**ADDENDUM NO. 2.0**

Date: 07/17/2023

**Project: Project #: 0110-464  
Ethel Phillips ES Telecenter Upgrade Project**

**AD 2.14:**

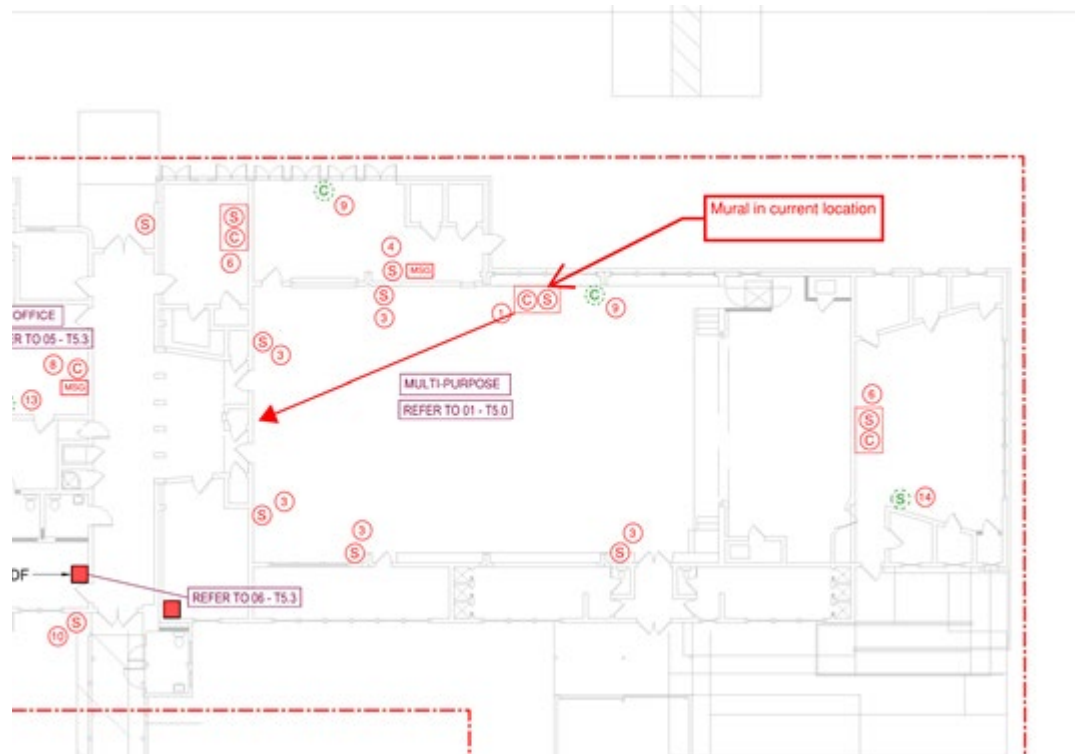
**Question:** Please see the location change of clock/speaker in Multi-Purpose Room

Proposed location change is acceptable.
